## **Port Central, Port Macquarie Development Application**

Port Central Retail Extension

We refer to recent correspondence from Council seeking additional information to assist in Council's assessment of the abovementioned DA. In response to the items in your correspondence, we provide the following information:

DRAWING TITLE: 115 PROPOSED GA PLANS Proposed Plan - Level 02

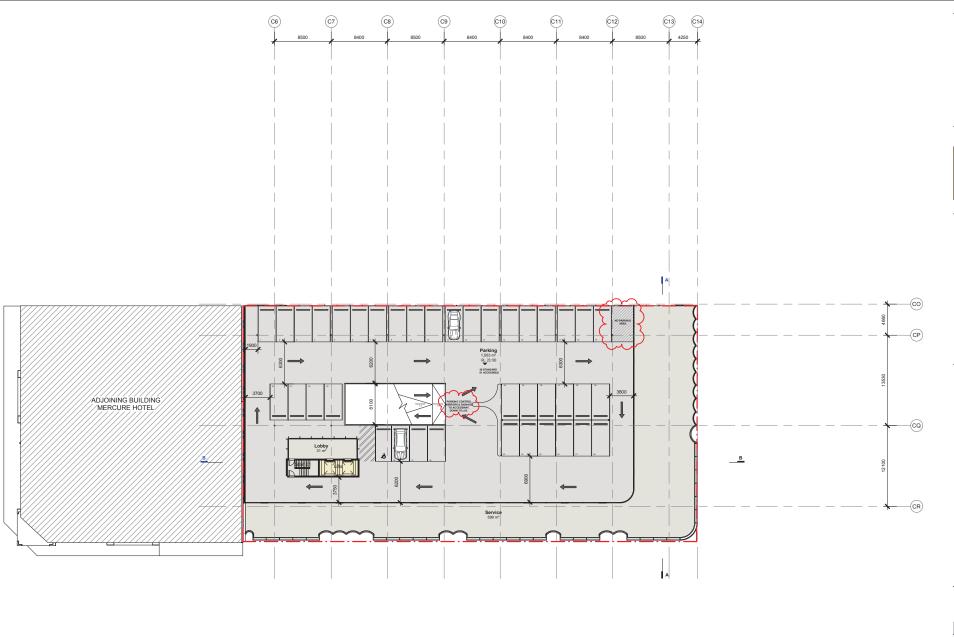
6. The amenities detail appears to be missing from Drawing DA-11504. Please clarify if this is the case and provide amended plans.

<u>Comment:</u> The amenities detail on Drawing DA-11504 has been reincluded in the updated architectural sheet-set.
